LB9034LWBR1S-D 2025-01-06 (用13mm长的针)

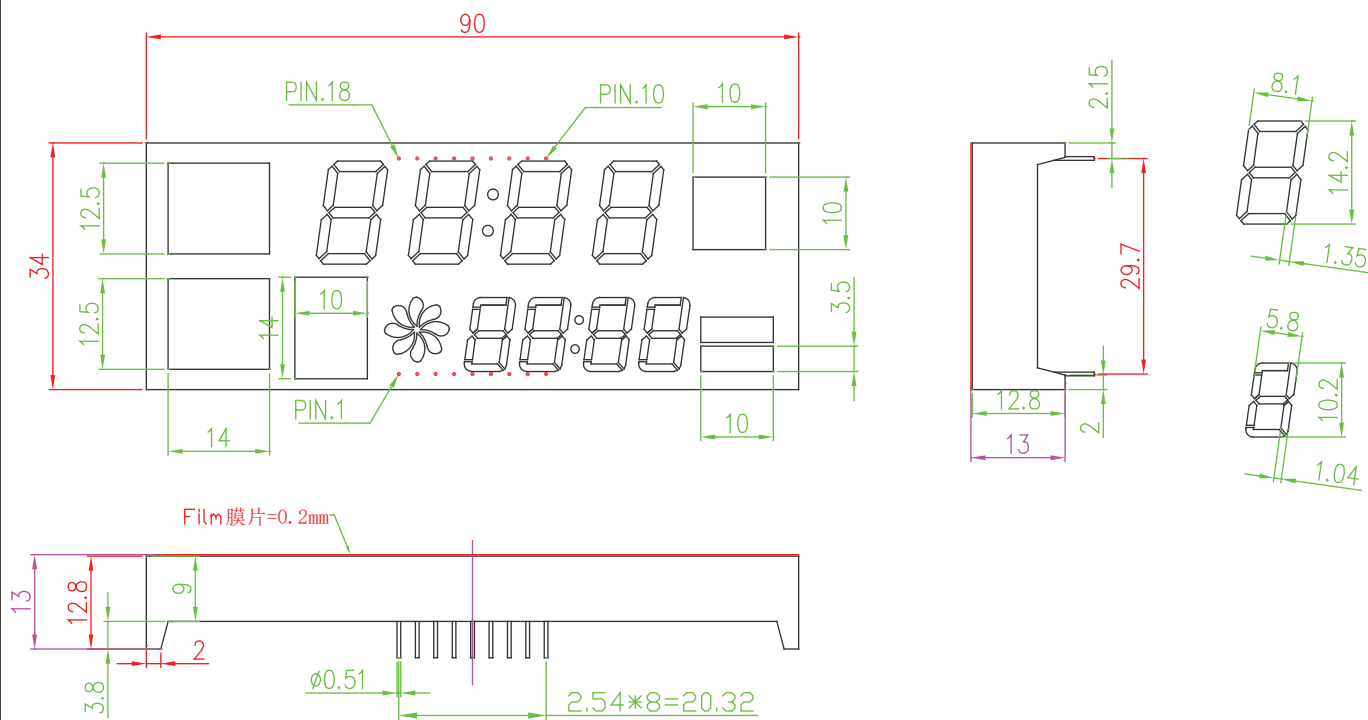
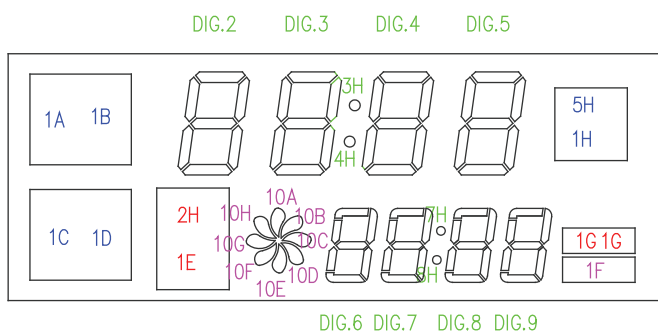
*1. 壳子高度改为12.8mm

*2. TIMER图案(1G)增加1颗芯片，2颗芯片并联
